TO: Dr. Jesse Bacon, Superintendent
FROM: Danny Clemens, Director of Facilities
Date: April 18, 2024
RE: Bernheim - Change Order 10 - Concrete Patio Replacement **DC**

PROJECT: *(Name and address)*
Bernheim Middle School Renovation
700 Audubon Drive, Shepherdsville, KY
40165

CHANGE ORDER INFORMATION:
Change Order Number: 010
Date: April 22, 2024

Change Order Request 15 - PCO #46 - RFP-12 Concrete Patio at Art and Science Classroom

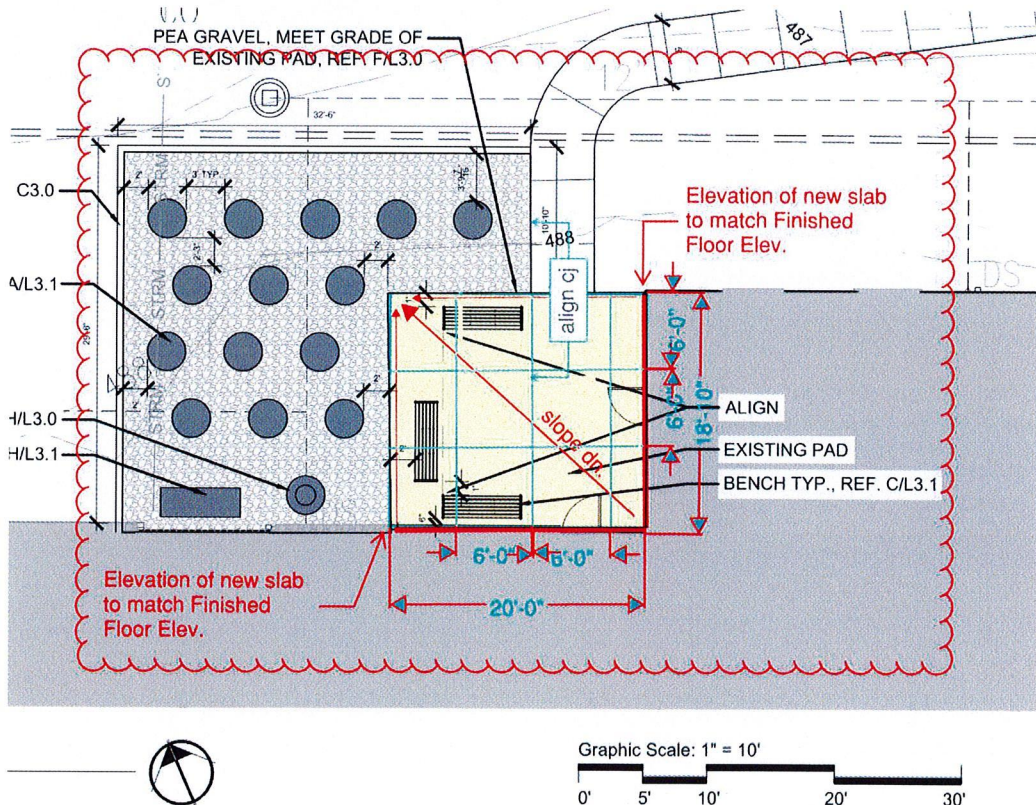
- Item 1:** REFERENCE SKETCH BELOW (Response to RFI #53 - Concrete Patio at Art and Science Classroom)
- Demolish existing slab on grade for installation of new sanitary main as documented on P2.1A/P3.1A.
 - Provide new 4" concrete slab on grade per Civil Details A and B on C3.0.
 - Provide New Concrete Slab as sketched below:

We propose to furnish all labor, materials, equipment and supervision to perform the following scope of work required for the placement 18' x 20' Concrete Patio at Art and Science Classroom:

- Demo existing concrete pad
- Excavate and remove debris from existing pad and subgrade
- Furnish and place 4" DGA
- Furnish, place and finish 4" of 4000 PSI concrete pad (20' x 18')
- Furnish and install wire mesh
- Sawcut and cleanup
